DIAMOND SPRINGS
PROJECT

Submitted by Diane
morillo
at Board Hearing of 12/18/12
#57 12-1540 A 1 of 1

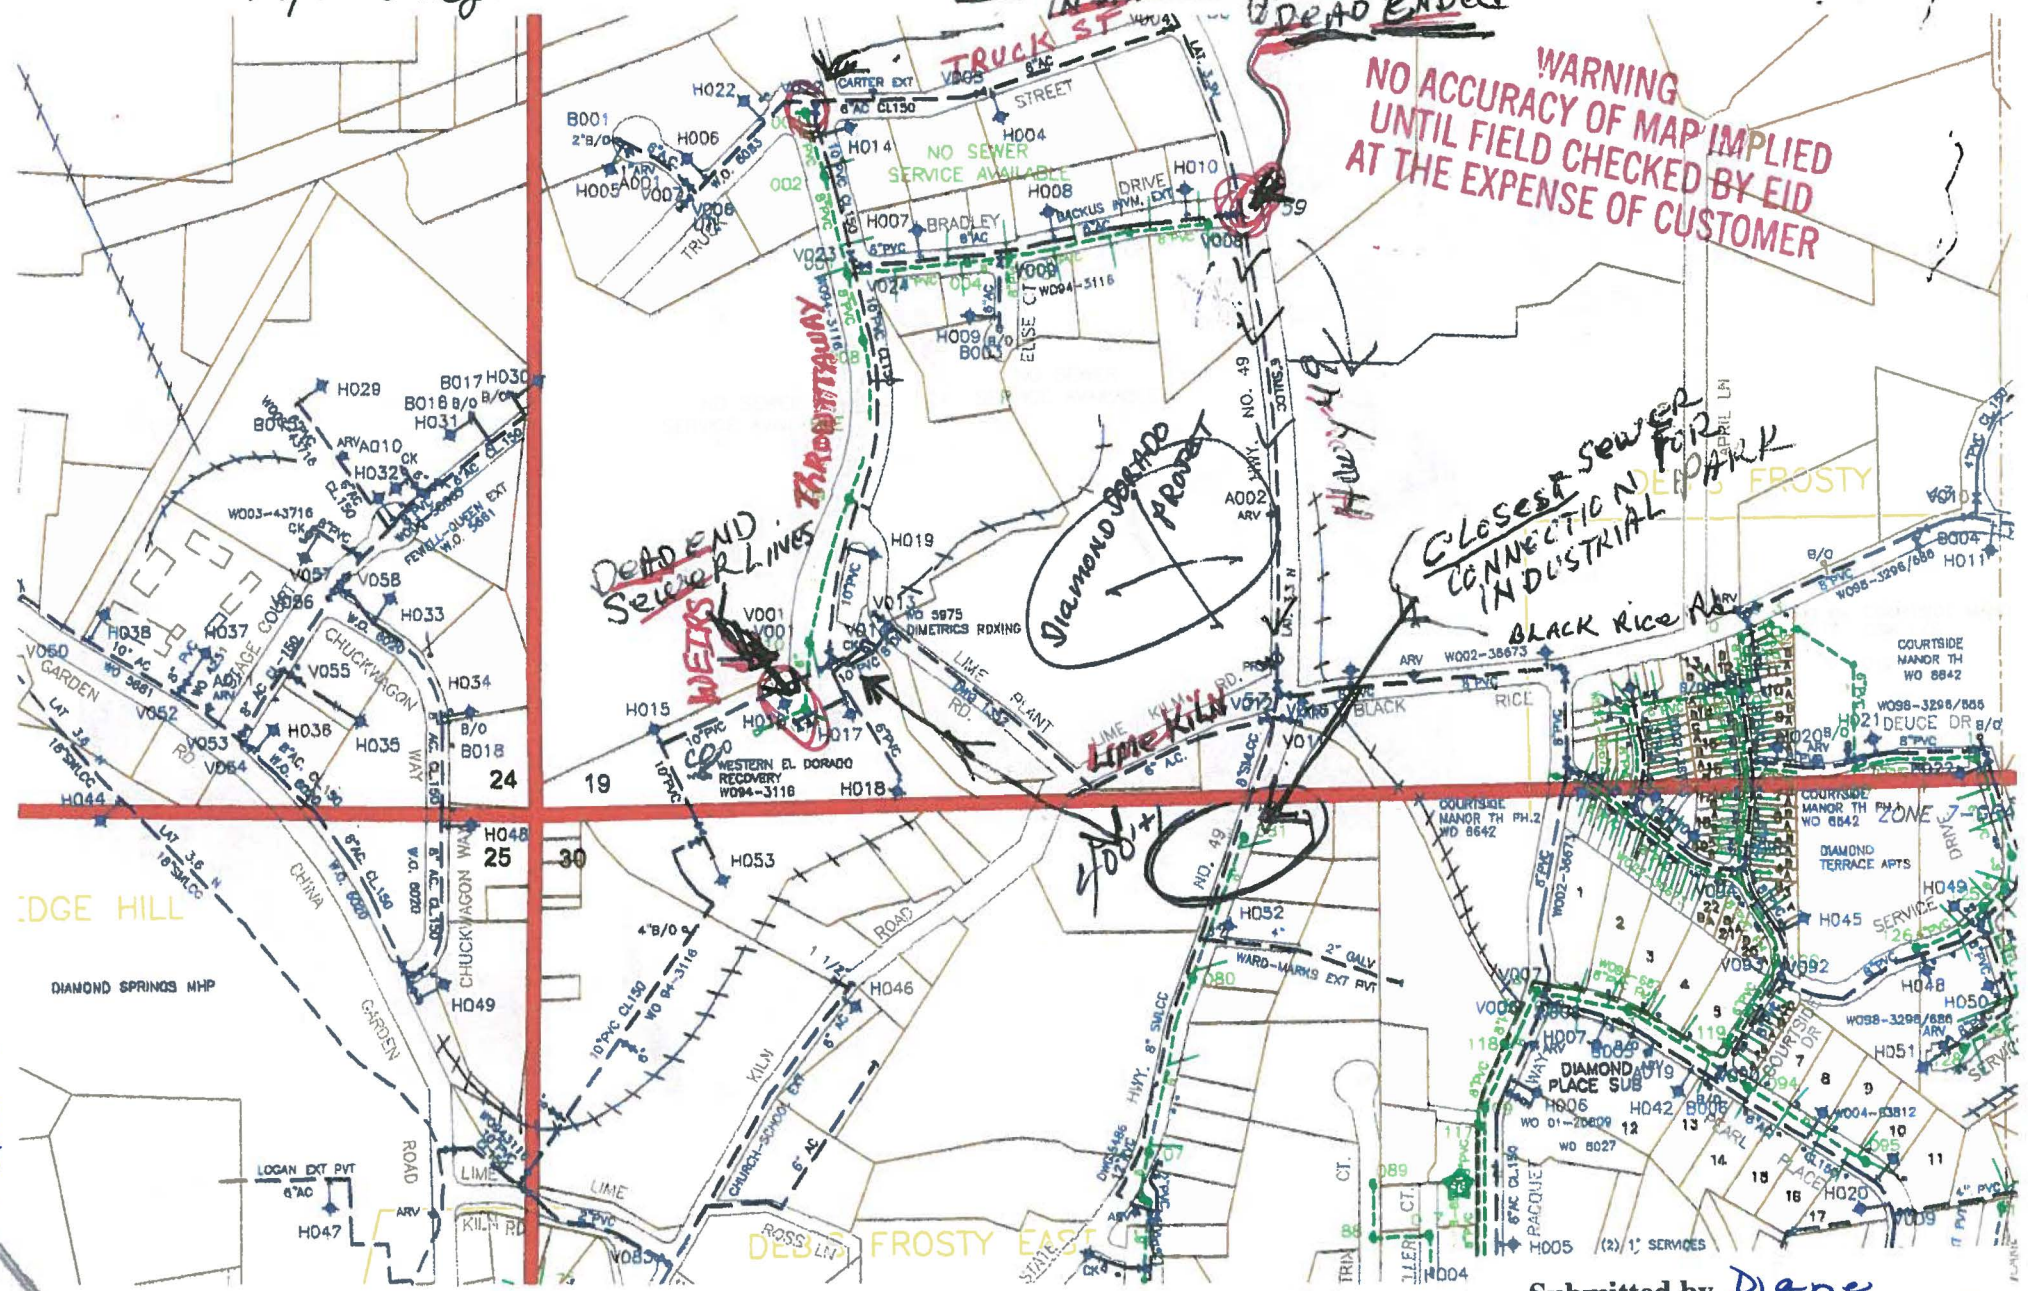
Area is included in Project VEIR Study Area
GENERAL PLAN 5.3.1.1. Requires Sewer
D.S./EL 00. Region 7

* D.S. SWR ~~0.000~~ E.I.D
+ 875 / per edge

DEAD END
SEWER LINES
WELLS

Closest sewer
CONNECTION
IN INDUSTRIAL
PARK
